Memo: TLR951x Errata

From: Telink Semiconductor

This document presents Errata information for the TLR951x chip A0 and A1 version engineering sample (ES). This document applies to the chip with marking shown below.

The SoC is marked as following (take TLR9518 as an example),

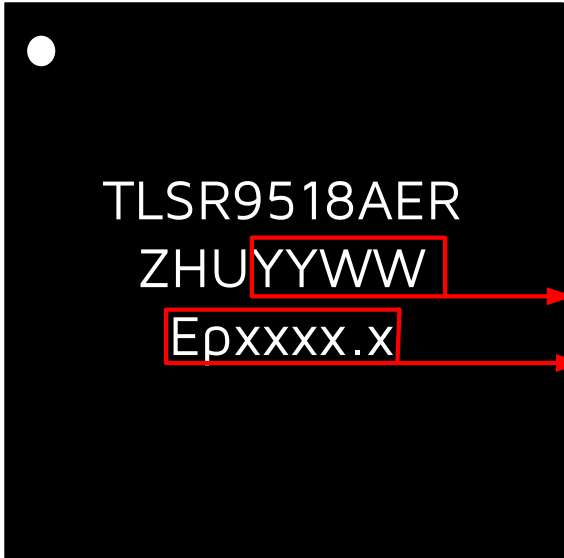
Product Series	Lot. No.	Version ID
TLR951x A0 Version	EP8616& EP8616.69	0xFF
TLR951x A1 Version	EP9044.12& EP9044.13	0xFE
TLR951x A2 Version	EP9327.14	0xFA

Note: Version ID can be read from register 0x140e02[1:0].
